O'REILLY AUTO PARTS PARKER, CO (PK2)

PROJECT:
NEW O'REILLY AUTO PARTS STORE
STROH RD
PARKER, CO #2

SITE PLAN COVER SHEET

1 IRRIGATION PLAN

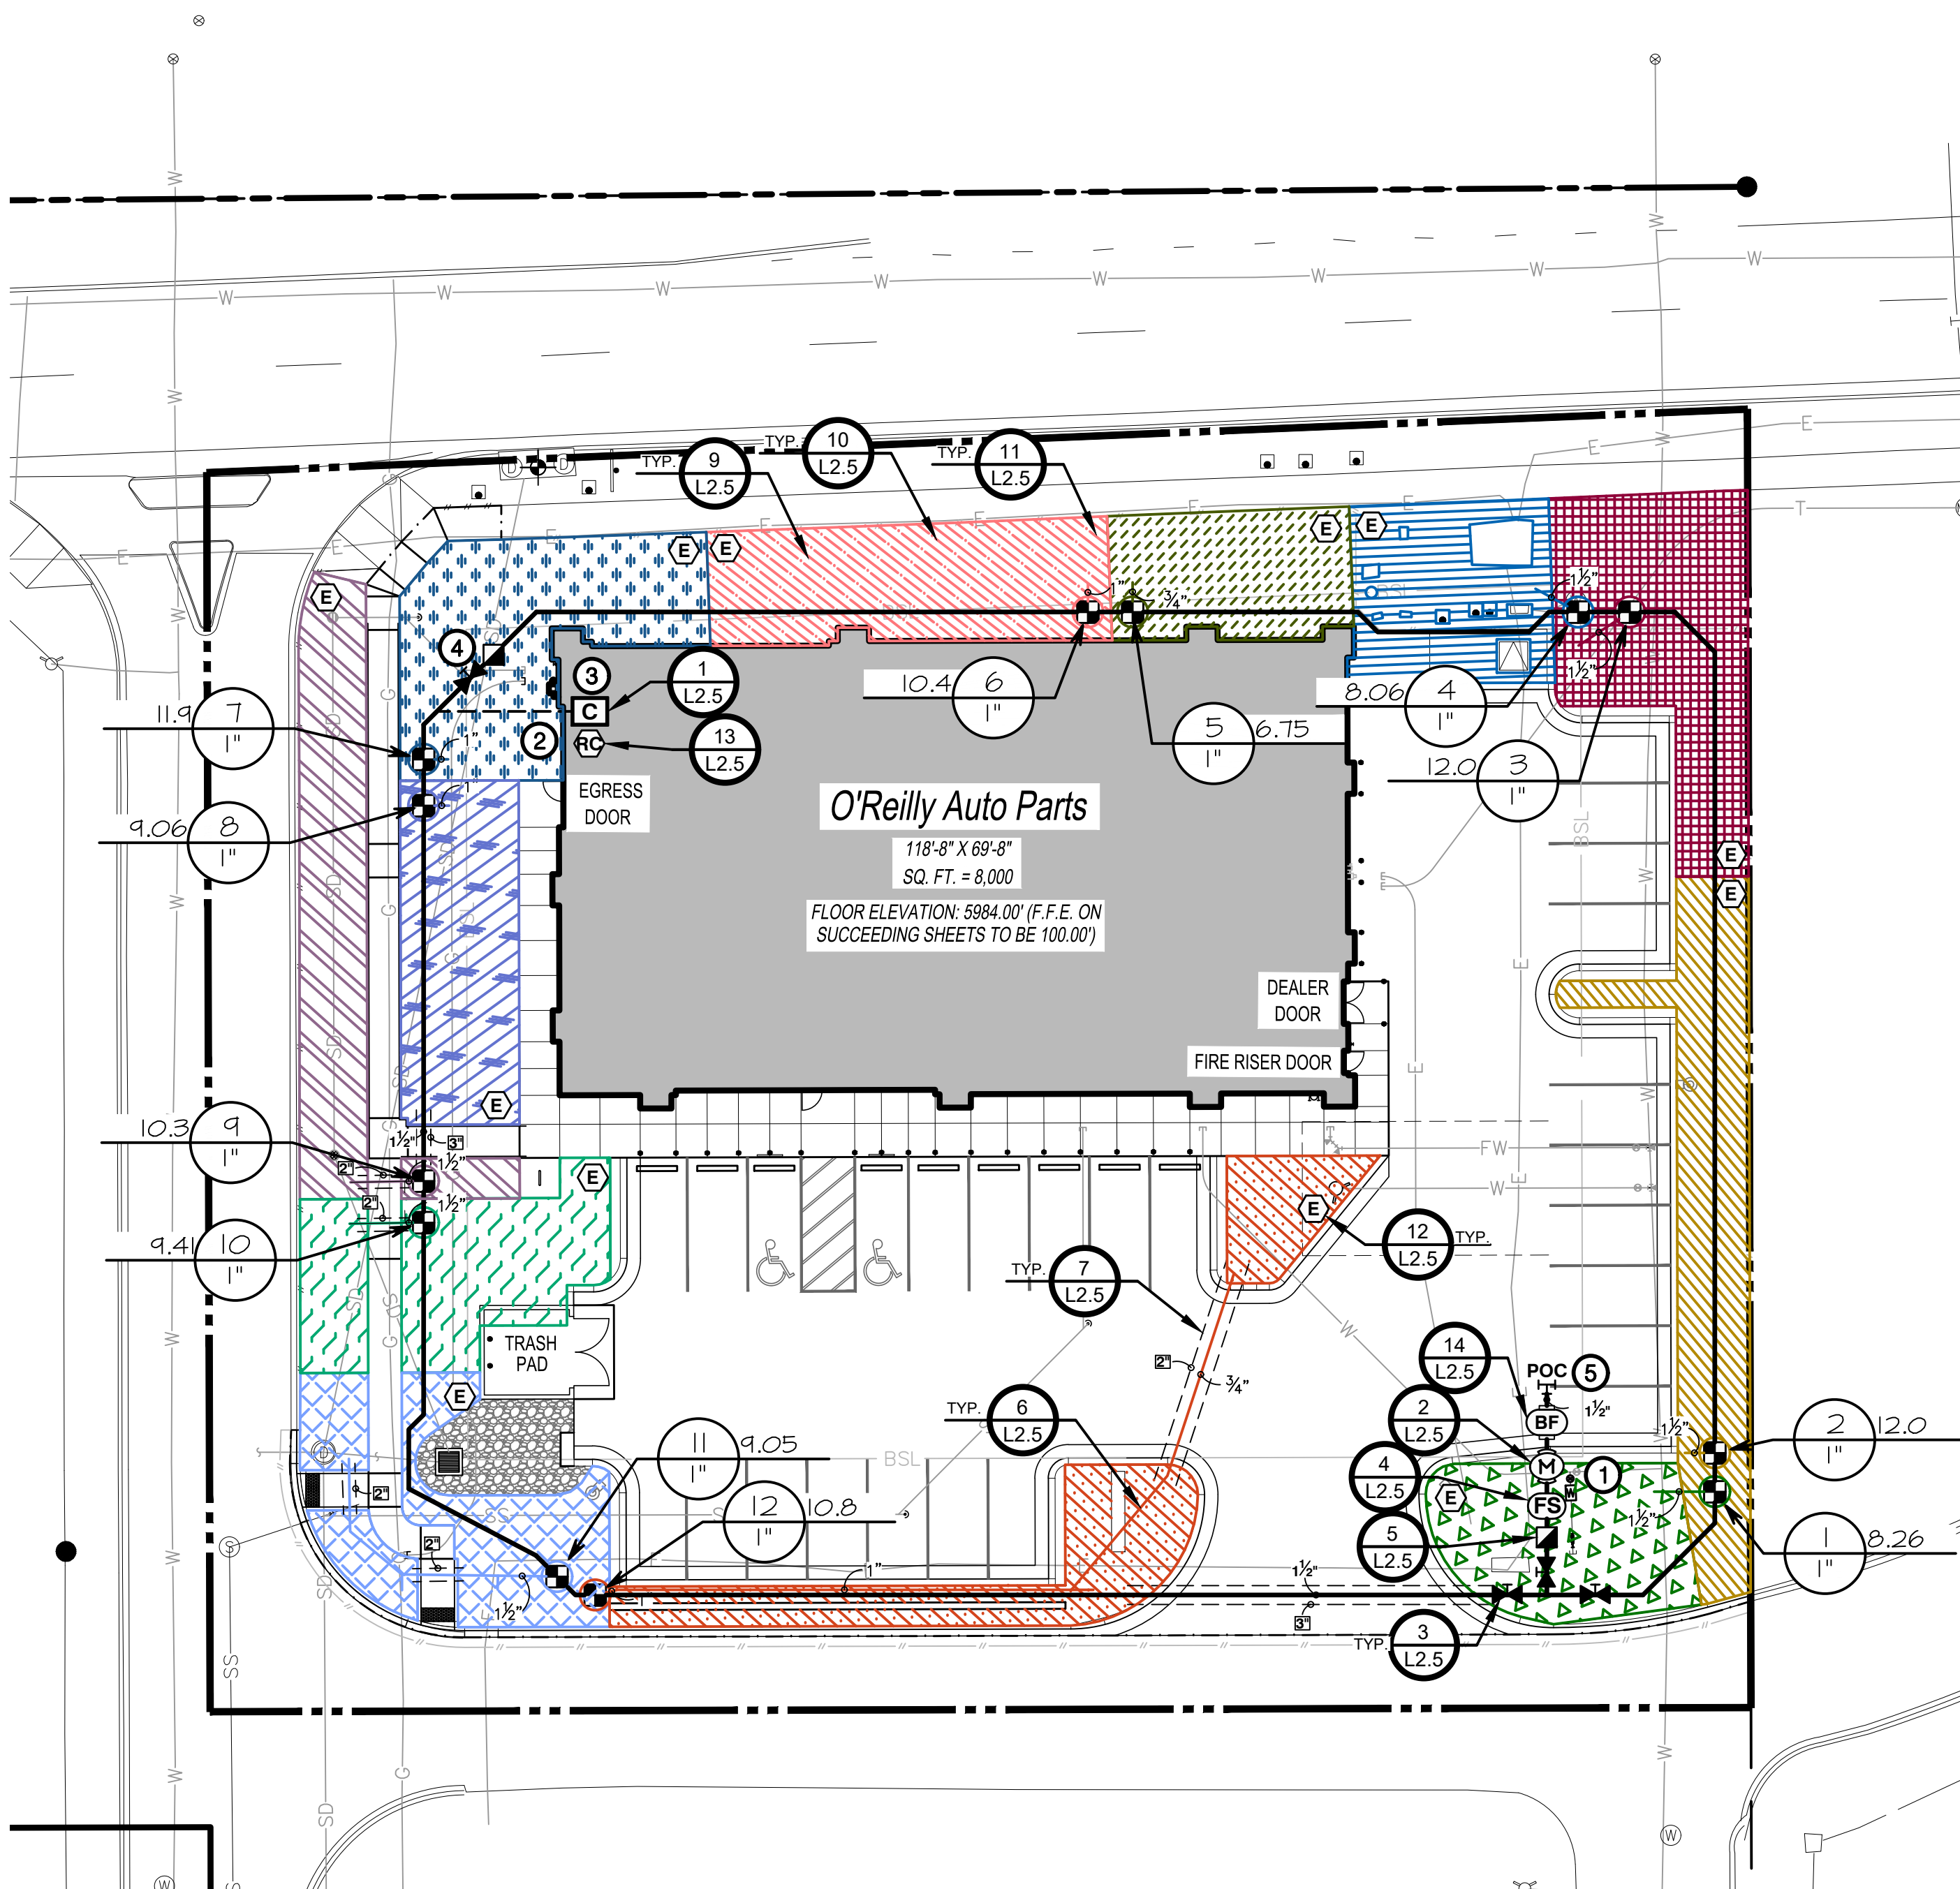
The minimum offset distance of any trees to edge of storm pipe/inlet is 7 feet per SDECM Section 6.3.3.2. Please adjust plans to accommodate the minimum 7 foot separation.

Breckon Response: Revised tree locations to be away from any pipe or inlet.
